RE: COMMENTS ON UCSC 2021 LRDP DRAFT EIR

Thank you for the opportunity to comment on the 2021 Draft Long Range Development Plan's (LRDP) Draft Environmental Impact Report (DEIR).

Figure 3.10-1 Watersheds and Sub-Basins on UC Santa Cruz Campus

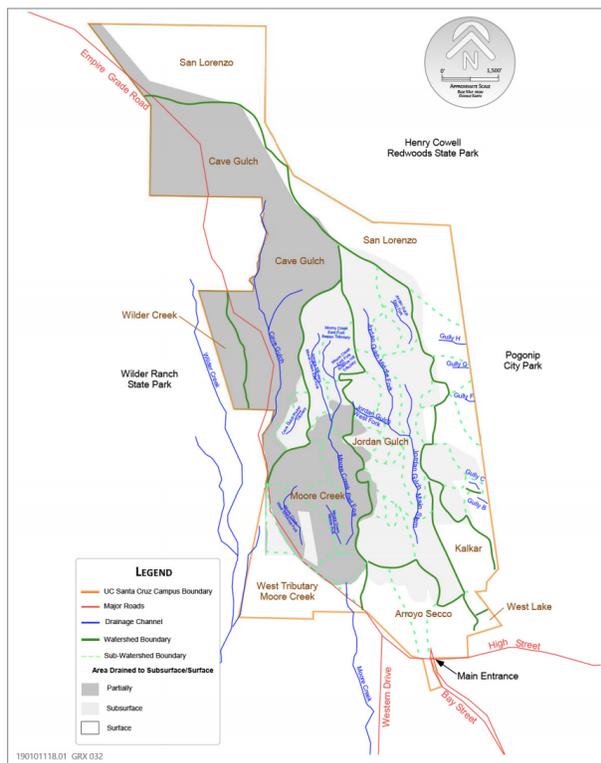
The draft 2021 LRDP proposes to develop 43% of the student housing and 8% of the academic and support space in North Campus, which is in a designated high fire hazard severity zone by the State. Because human beings are a primary cause of wildfire, the addition of a minimum of 3,700 people to this vulnerable area will dramatically increase the risk of wildfire in a region that was previously unpopulated. The EIR should also include an analysis and propose mitigations for reducing the impact of wildfire on the campus' water resources, particularly the San Lorenzo Valley Watershed.

As Figure 3.10-1 Watersheds and Sub-Basins on UC Santa Cruz Campus shows, the “...northeastern and eastern boundary of the main residential campus is drained mainly by a series of hillslope drainages within the San Lorenzo River watershed. In general, the San Lorenzo – Pogonip watershed drains much of the eastern portion of the main residential campus east of Hagar Drive from north of the Crown-Merrill Apartments south to the southern boundary of the campus and borders the City of Santa Cruz’ Pogonip Park to the east of campus.”

Additionally, “Eight sub-watersheds comprise the larger area that are associated with a number of west-east trending gullies (Gullies A through H) that drain to the east (see Figure 3.10-1).”
